Agency Comments

Contra Costa County
Public Works
Department

SUBJECT: **SUBDIVISION SD13-9359/DP13-3035/RZ13-3224/GP13-0003**
"Saranap Village"
STAFF REPORT & CONDITIONS OF APPROVAL
(Hall Equities/Boulevard Way/Walnut Creek/ APNs 184-010-046 & 035, 184-480-025, 185-370-010, 012, 018, 033)

Figure 5: RZ-13-3224 & SD13-9359 Parcel Map showing Boreholes

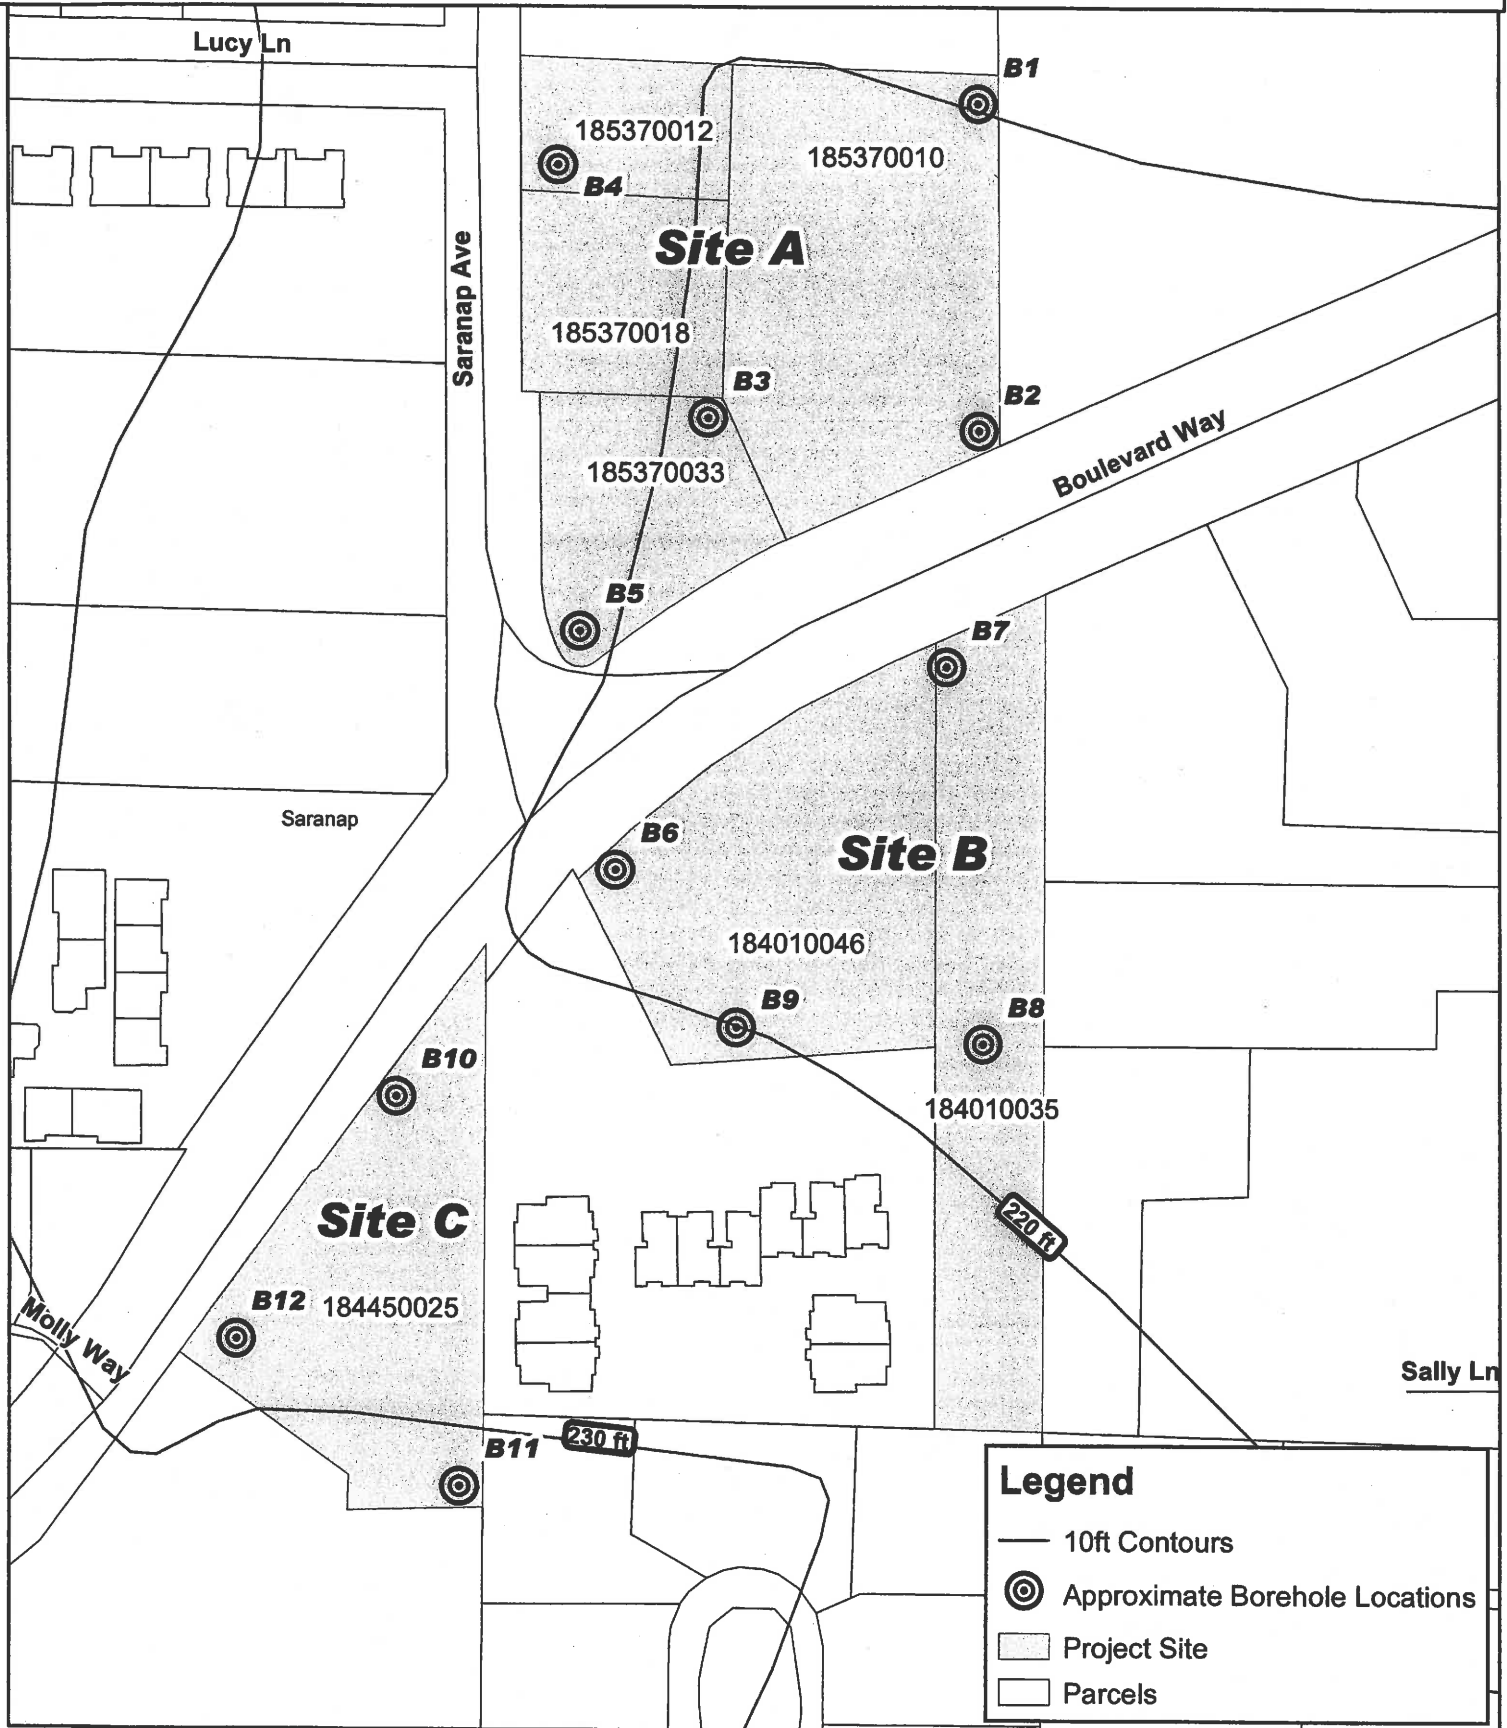
Figure 5, Parcel Map Showing Boreholes, identifies the Rockridge study area (subject property identified with a pale blue color). The map provides Assessor Parcel Numbers and identifies the location of Sites A, B and C. The map also shows the local road network, and provides topographic contours (10 ft. contour interval) and shows the approximate location of the exploratory borings.
